SUBJECT: Forwards suppl to 880122 proposed amend to Licenses DPR-38, DPR-47 & DPR-55 re limited MALHR.

Subject: Oconee Nuclear Station
Docket Nos. 50-269, -270, -287
LOCA - Limited Maximum Allowable
Linear Heat Rate

LOCA Limits for Low Pre-Pressure Fuel Rods

Oconee Nuclear Station
Figure 3.5.2-16

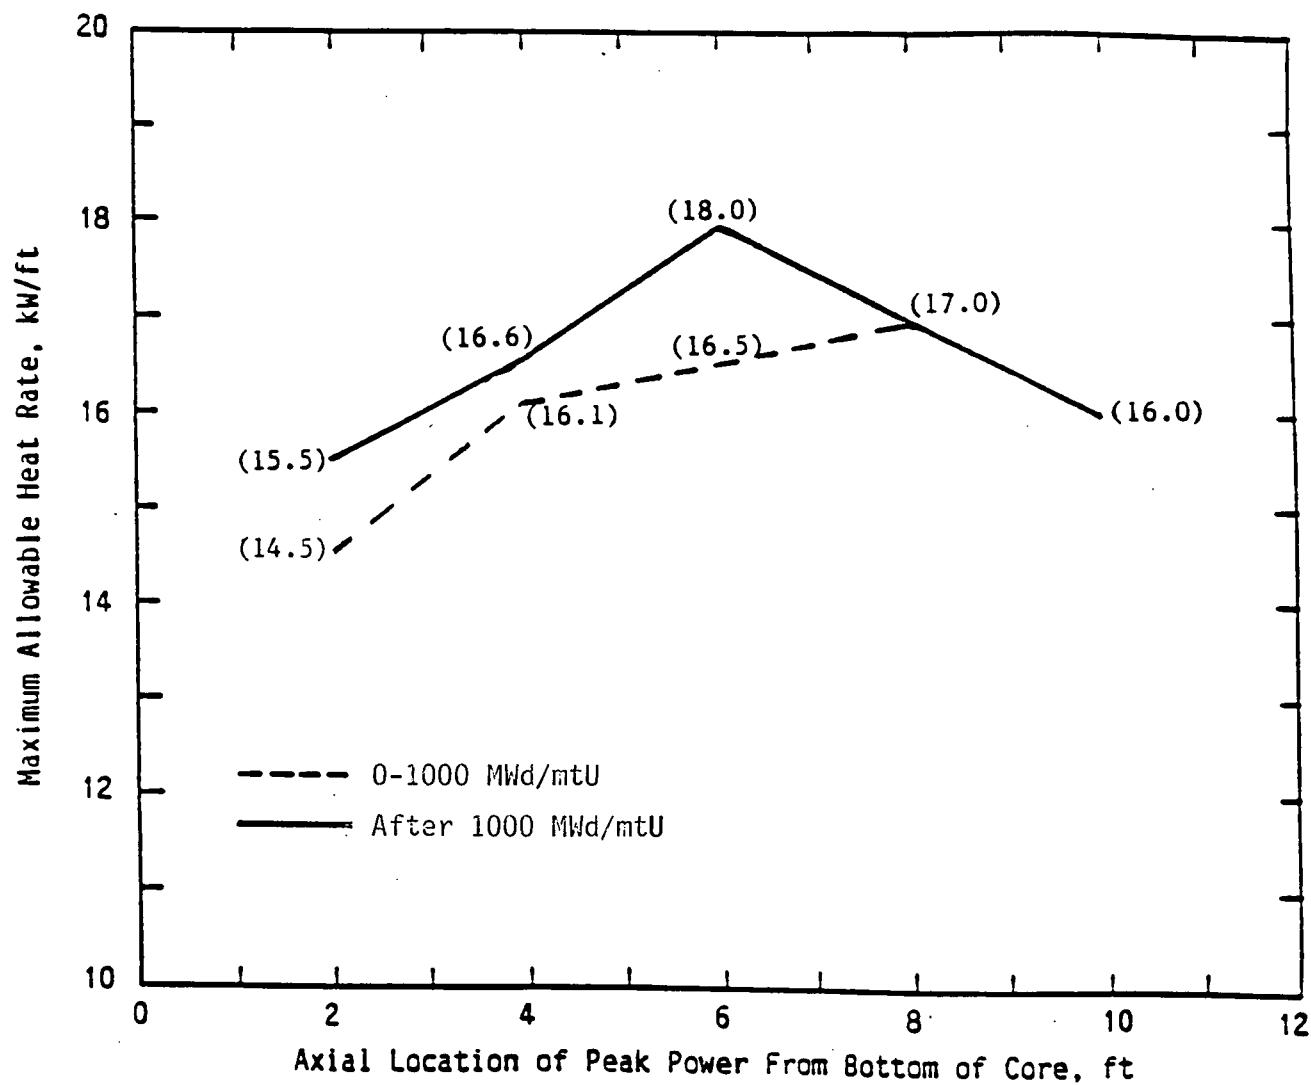
By letter dated January 22, 1988 I submitted a proposed amendment to the Oconee Nuclear Station (ONS) Facility Operating License and revision to the ONS Technical Specification Bases. The proposed revision was provided to update the LOCA - Limited Maximum Allowable Linear Heat Rate (Figure 3.5.2-16) in accordance with the technical justification provided in B&W Owners Group Report BAW-2001P, Low Pre-Pressure Fuel Rod Program.

Please find attached a supplement to the January 22, 1988 amendment request. This supplement represents the results of analyses described in BAW-2001P with two burnup windows rather than three. The attached letter (Attachment 2) is provided to supplement Table 3 of BAW-2001P. The LOCA kw/ft limits provided in this supplement and the limits described in Table 3 of BAW-2001P will not violate 10CFR50.46 or 10CFR50, Appendix K requirements. As such, no changes to the previously submitted No Significant Hazards Consideration Evaluation are necessary.

Table 3 of Reference 1 may have a supplement added to it to include the following table:

Core Elevation (ft)	<u>LOCA Limits</u>	-	<u>Linear Heat Rates (kw/ft)</u>
	BOL-1000 MWD/mtu		1000 MWD/mtu-EOL
2	14.5		15.5
4	16.1		16.6
6	16.5		18.0
8	17.0		17.0
10	16.0		16.0

Both Table 3 of Reference 1 and this supplement are equally valid and will not violate 10 CFR 50.46 and Appendix K requirements of
